Engineering Change Request		ECR Number	R10516W
Initiator:	Max.Ma	Date:	2026.07.28
Part number description			
Item	K3 Code material part numbers	Drawing/ Doc Number	Version of current related document
1	GEN2 600A CCS1 plug series	All part number drawings, see attached list.	/
2	GEN3 600A CCS1 plug series	All part number drawings, see attached list.	/
3	GEN3 600A NACS plug series	All part number drawings, see attached list.	/
Reason of change:			
☐ Customer requirement (list the feasibility analysis of customer specification: _____)			
☐ Supplier request (list the PCR number: _____)			
☒ Internal improvement ☐ corrective ☐ other			
Please describe here in detail:

Engineering Change Request		ECR Number	R10516W
Initiator:	Max.Ma	Date:	2026.07.28
Part number description			
Item	K3 Code material part numbers	Drawing/ Doc Number	Version of current related document
1	GEN2 500A CCS2 plug series	All part number drawings, see attached list.	/
2	GEN3 500A CCS2 plug series	All part number drawings, see attached list.	/
Reason of change:			
☐ Customer requirement (list the feasibility analysis of customer specification: _____)			
☐ Supplier request (list the PCR number: _____)			
☒ Internal imp

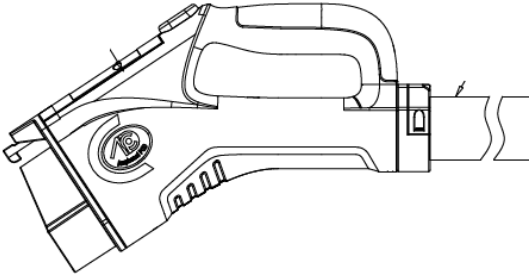
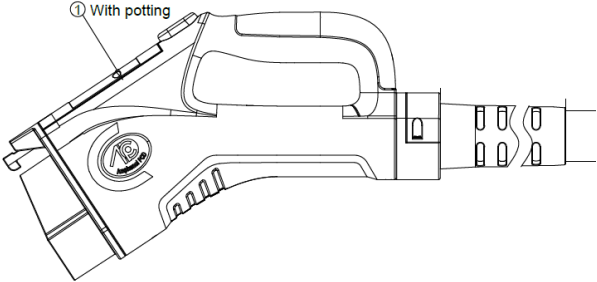
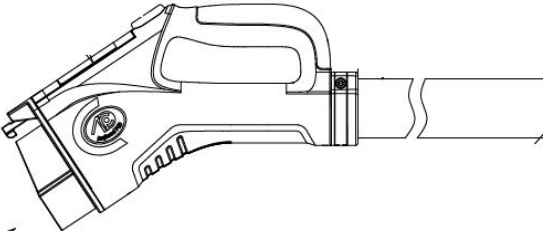
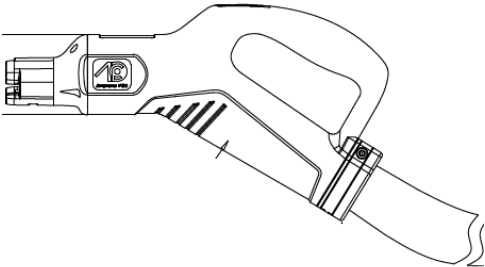
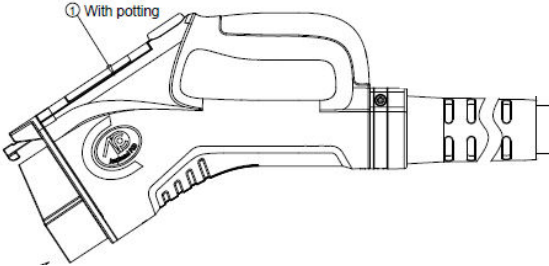
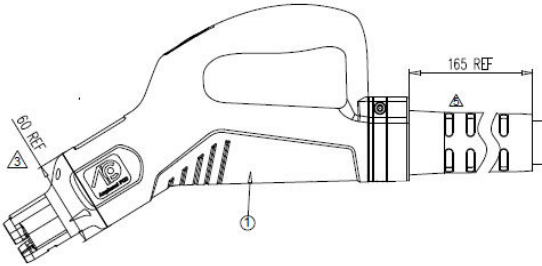
1. Install an SR at the gun-cable joint to prevent over-bending during field use.			
2. UL certification has been filed.			
Change level and impact assessment (Please tick in the appropriate position)			
Change level	Change content	Concerned area (Shenzhen, Hermosillo, Chennai)	Whether to notify the customer
Level 1	☐ Operator change		☐ It is not necessary to notify the customer for approval
	☐ Correct the clerical errors of the drawing, BOM, etc., and this change will not affect the production process		
Level 2	☐ Change of Main production equipment or tools/Jigs		☒ <u>Customers should be notified for approval</u> ☐ <u>It is not necessary to notify the customer for approval, the reasons are as follows:</u>
	☐ Change of main measuring equipment or tools/Jigs		
	☐ Appearance changes that do not affect product functions		
	☐ Changes in production process or processing technology		
	☐ Product structure or specification changes that have not been transferred to mass production

Before change 1.CCS1 : Gen2 Without SR 		After change 1.CCS1 : Gen2 With SR 	
2. CCS1 NACS: Gen3 Without SR  		2. CCS1 NACS: Gen3 With SR  	
Disposition of old materials ☐ Rework ☒ Use as it is ☐ scrap ☐ Other (please describe): _____ ☐ N/A			Expect date to switch to new material <u>2026.09.30</u>
Approval by the supervisor of requester.: <i>Ben</i>		Approval by the head manager of the request dept.: <i>Chinghung</i>	
Customer approval: ☐ Approved ☐ No approved ☐ Conditional approval (please describe) : Signature: _____ Date: _____			
Remark:

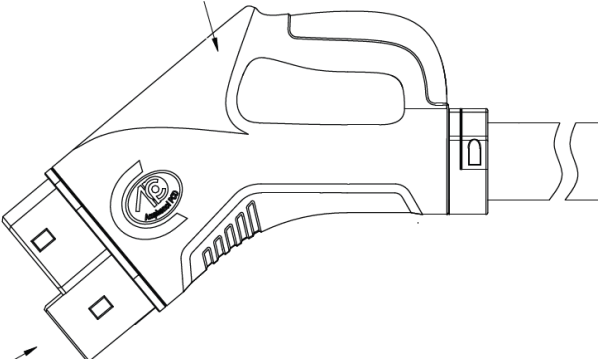
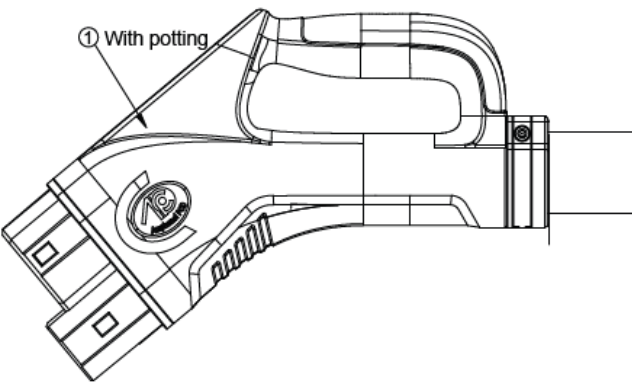
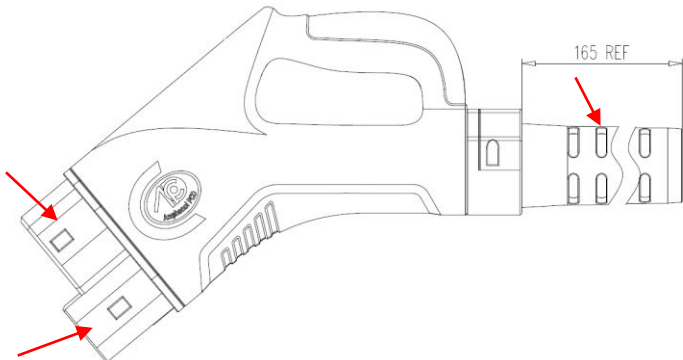
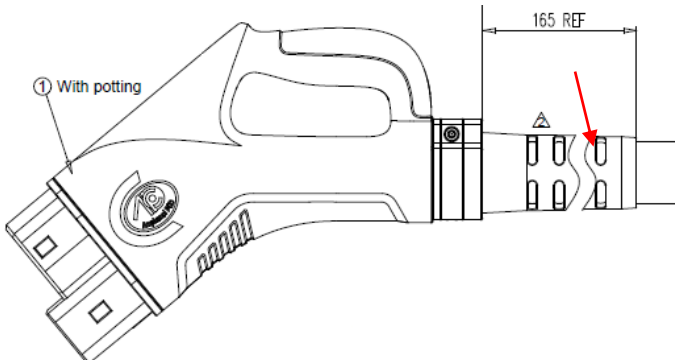
1. Install an SR at the gun-cable joint to prevent over-bending during field use. 2. Ribs are added to Gen2 vehicle connector. 3. Certification is expected to be completed in August.			
Change level and impact assessment (Please tick in the appropriate position)			
Change level	Change content	Concerned area(Shenzhen, Hermosillo, Chennai)	Whether to notify the customer
Level 1	☐ Operator change		☐ It is not necessary to notify the customer for approval
	☐ Correct the clerical errors of the drawing, BOM, etc., and this change will not affect the production process		
Level 2	☐ Change of Main production equipment or tools/Jigs		☒ <u>Customers should be notified for approval</u> ☐ <u>It is not necessary to notify the customer for approval, the reasons are as follows:</u>
	☐ Change of main measuring equipment or tools/Jigs		
	☐ Appearance changes that do not affect product functions		
	☐ Changes in production process or processing technology

Before change 1. CCS2 : Gen2 Without SR and Rib  2. CCS2: Gen3 Without SR 		After change 1. CCS2 : Gen2 With SR and Rib  2. CCS2: Gen3 With SR 	
Disposition of old materials ☐ Rework ☒ Use as it is ☐ scrap ☐ Other (please describe): _____ ☐ N/A		Expect date to switch to new material <u>2026.09.30</u>	
Approval by the supervisor of requester.: <i>Ben</i>		Approval by the head manager of the request dept.: <i>Cheng Huang</i>	
Customer approval: ☐ Approved ☐ No approved ☐ Conditional approval (please describe) : Signature: _____ Date: _____			
Remark:
